Final Product/Process Change Notification

Document #:FPCN27309X

Title of Change:	Additional Assembly and Test Site for QDual3 IGBT Package at Shenzhen, China.																				
Proposed First Ship date:	15 Aug 2026 or earlier if approved by customer																				
Contact Information:	Contact your local onsemi Sales Office																				
PCN Samples Contact:	Contact your local onsemi Sales Office. Sample requests are to be submitted no later than 30 days from the date of first notification, Initial PCN or Final PCN, for this change. Samples delivery timing will be subject to request date, sample quantity and special customer packing/label requirements.																				
Additional Reliability Data:	Contact your local onsemi Sales Office																				
Type of Notification:	This is a Final Product/Process Change Notification (FPCN) sent to customers. FPCNs are issued 90 days prior to implementation of the change. onsemi will consider this change accepted, unless an inquiry is made in writing within 30 days of delivery of this notice. To do so, contact PCN.Support@onsemi.com

onsemi Shenzhen, China marking style:

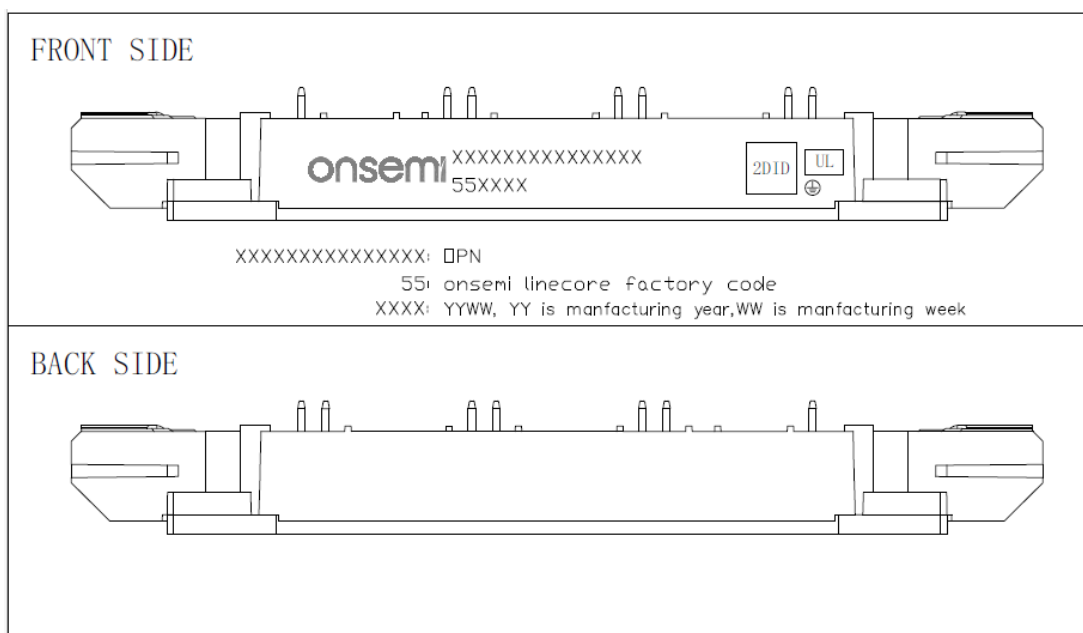
Before Change Description	After Change Description																			
Assembly Site	Linecore	onsemi Shenzhen, China Linecore																			
Test Site	Linecore	onsemi Shenzhen, China Linecore																			
Product marking change	Linecore making style	onsemi Shenzhen, China marking style Linecore making style																			
Take NXH800H120L7QDSG as example, SNXH800H120L7QDSG marking will be similar.																					
<table><thead><tr><th>Site</th><th colspan="2">onsemi Shenzhen, China</th><th colspan="2">Linecore</th></tr></thead><tbody><tr><td rowspan="3">Front side</td><td>OPN:</td><td>NXH800H120L7QDSG</td><td>OPN:</td><td>NXH800H120L7QDSG</td></tr><tr><td>Trace code:</td><td>\A\T/(YYWW)</td><td>Trace code:</td><td>\A\T/(YYWW)</td></tr><tr><td>Frontside 2DID:</td><td>NXH800H120L7QDSG (YYWW)\A\T/</td><td>Frontside 2DID:</td><td>NXH800H120L7QDSG\A\T/(YYWW)(ZZZZZZZZ)(NNNNNNNN)(+)(+)(+)</td></tr></tbody></table>				Site	onsemi Shenzhen, China		Linecore		Front side	OPN:	NXH800H120L7QDSG	OPN:	NXH800H120L7QDSG	Trace code:	\A\T/(YYWW)	Trace code:	\A\T/(YYWW)	Frontside 2DID:	NXH800H120L7QDSG (YYWW)\A\T/	Frontside 2DID:	NXH800H120L7QDSG\A\T/(YYWW)(ZZZZZZZZ)(NNNNNNNN)(+)(+)(+)

Site	onsemi Shenzhen, China		Linecore																		
Front side	OPN:	NXH800H120L7QDSG	OPN:	NXH800H120L7QDSG																	
	Trace code:	\A\T/(YYWW)	Trace code:	\A\T/(YYWW)																	
	Frontside 2DID:	NXH800H120L7QDSG (YYWW)\A\T/	Frontside 2DID:	NXH800H120L7QDSG\A\T/(YYWW)(ZZZZZZZZ)(NNNNNNNN)(+)(+)(+)

Back side	Backside 2DID:	(ZZZZZZZZZZ)(+)(NNNNNNNN)	Backside 2DID:	NA
-----------	----------------	---------------------------	----------------	----
